**APPLICATION FOR PERMISSION
UNDER SECTION 16 OF
THE TOWN PLANNING ORDINANCE
(CAP. 131)**

From: charles [REDACTED]
Sent: Tuesday, February 25, 2025 10:18 AM
To: Jackin Ho Yeung YIP/PLAND [REDACTED]
Subject: RE: A/SK-HC/366 取代 2 月 18 號, 2 月 19 號, 2 月 21 號及 2 月 25 號的電郵及補充有關 Lot No. 505 申請的資料

寄件者: charles <[REDACTED]>
寄件日期: 2025年06月11日星期三 16:54
收件者: Sally Sin Yi CHAN/PLAND
副本: [REDACTED]
主旨: RE: Application No. A/SK-HC/366 - Proposed Temporary Office with Ancillary Car Park for a Period of Three Years at Lot 505 in D.D. 210 and Adjoining Government Land, Luk Mei Tsuen Road, Ho Chung, Sai Kung
附件: attachement 2.pdf; attachement 3.pdf; attachement 1.pdf
類別: Internet Email

LEGEND:

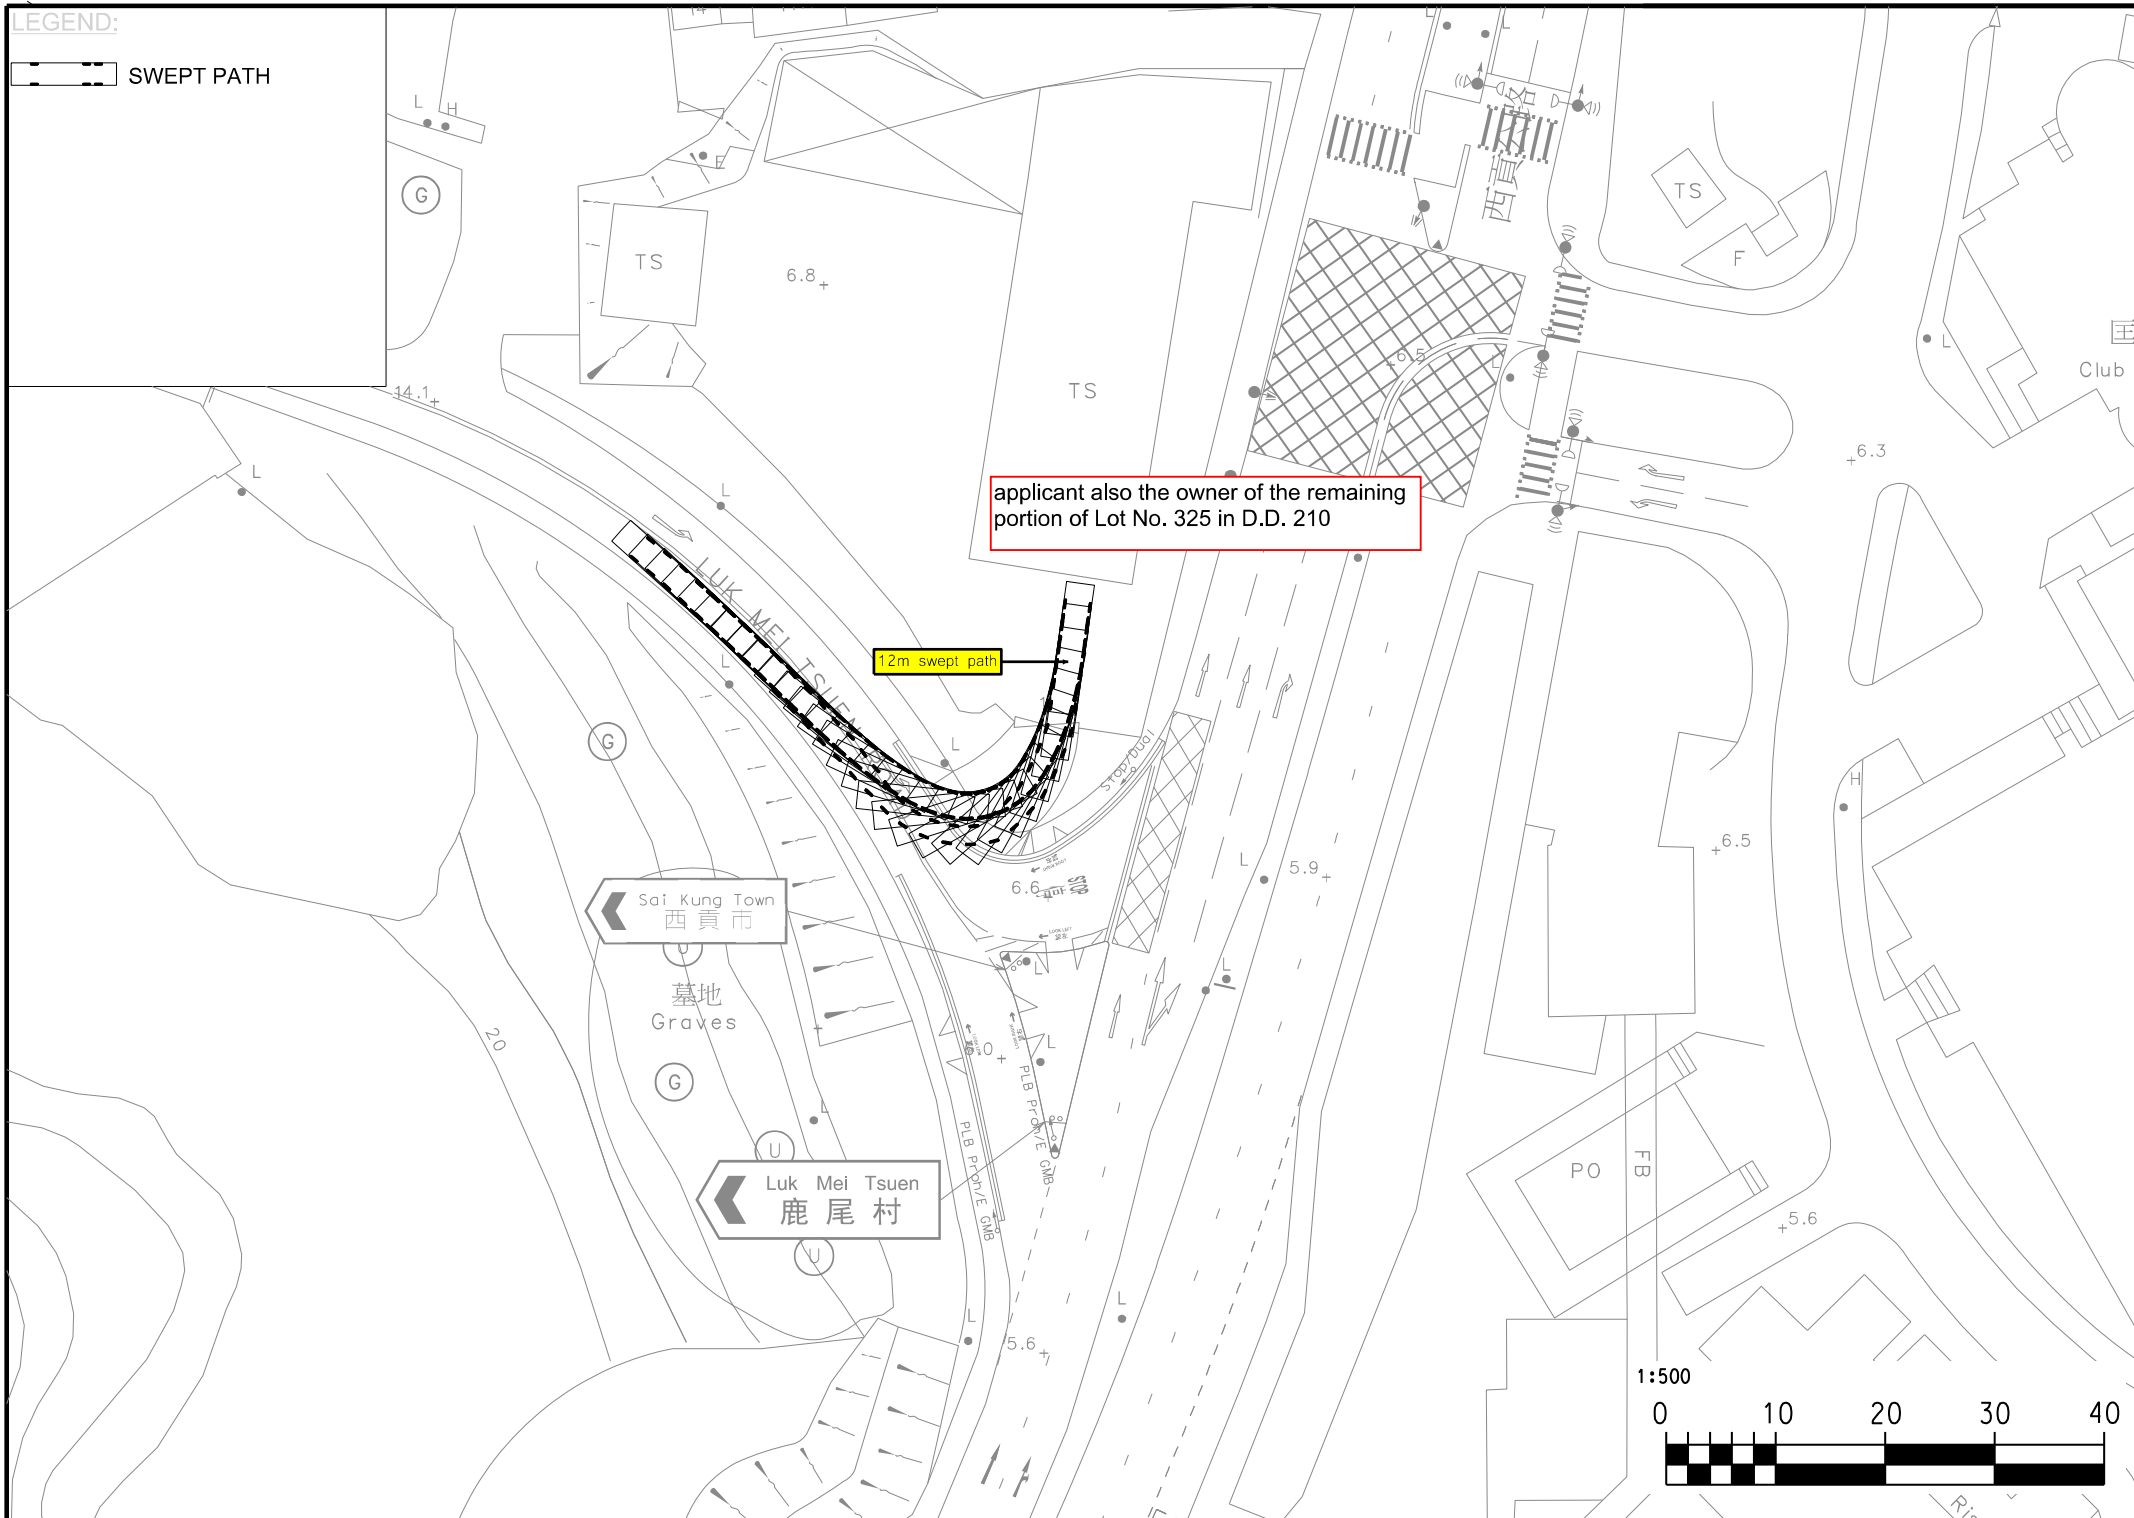
Refer to the comment from Transport Department.

1. Attached swept path analysis.
2. Our dimension of parking spaces should comply with planning standard
3. Enclosed with revised layout plan, according to the layout plan, there will be 1 no. of car park and 1 no. of loading/unloading space.
4. Attached swept path for car park.

LEGEND:

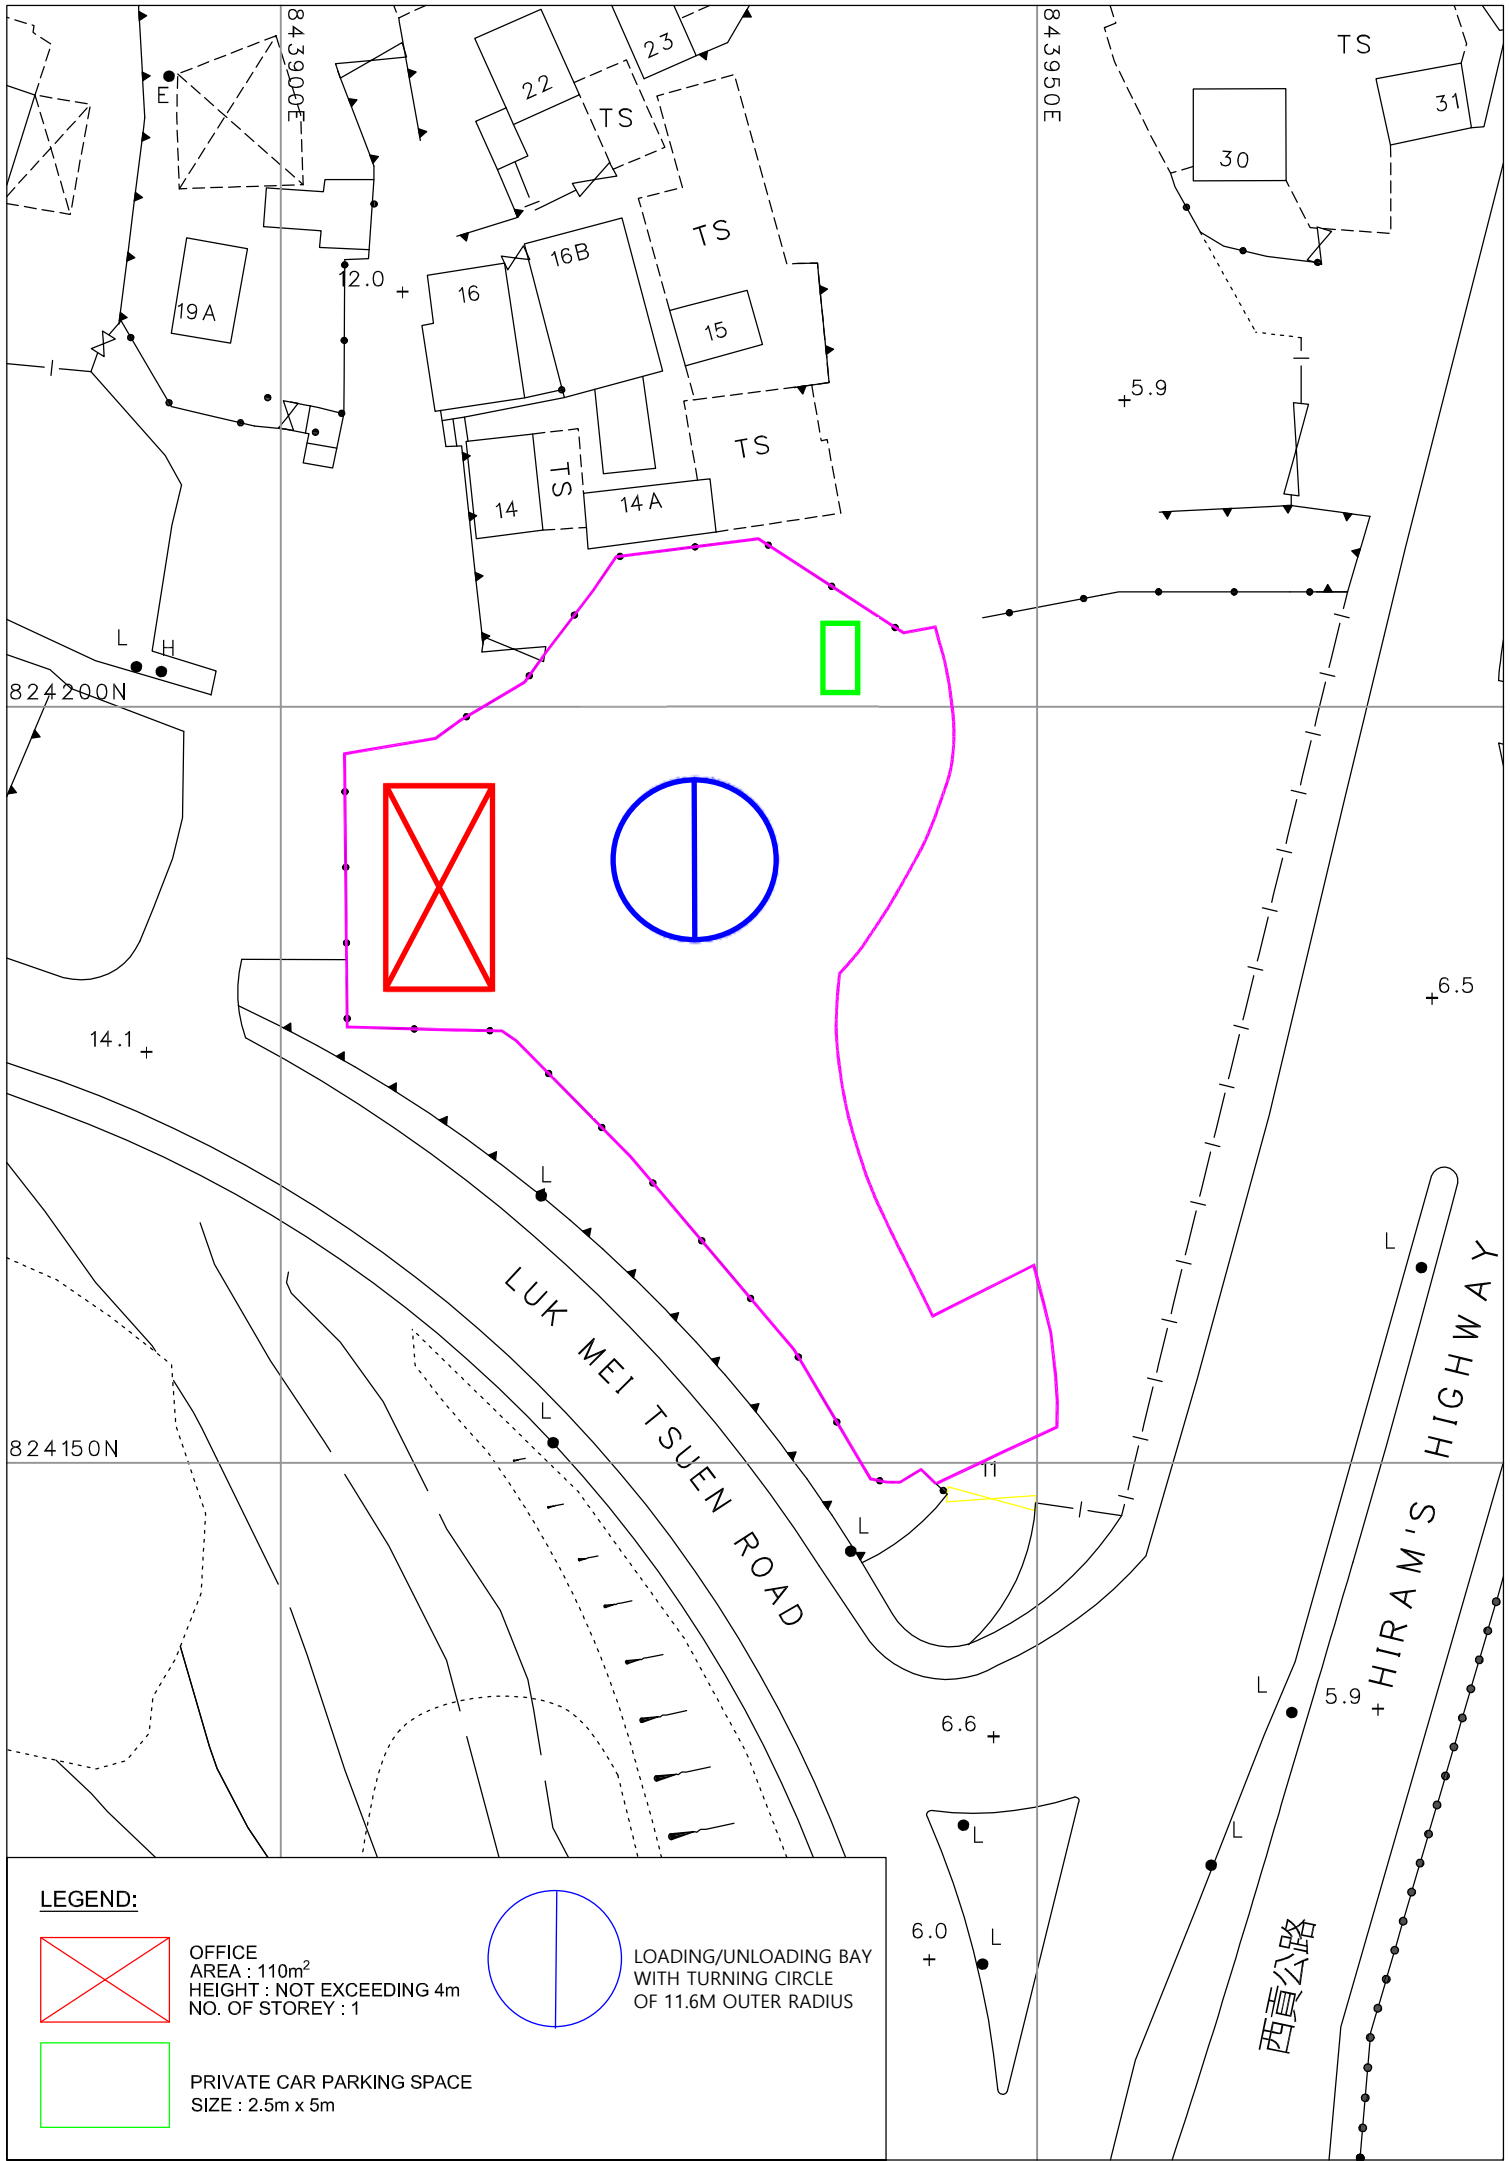
Refer to the comment from Transport Department.

PRIVATE CAR PARKING SPACE
SIZE : 2.5m x 5m

LOADING/UNLOADING BAY
WITH TURNING CIRCLE
OF 11.6M OUTER RADIUS
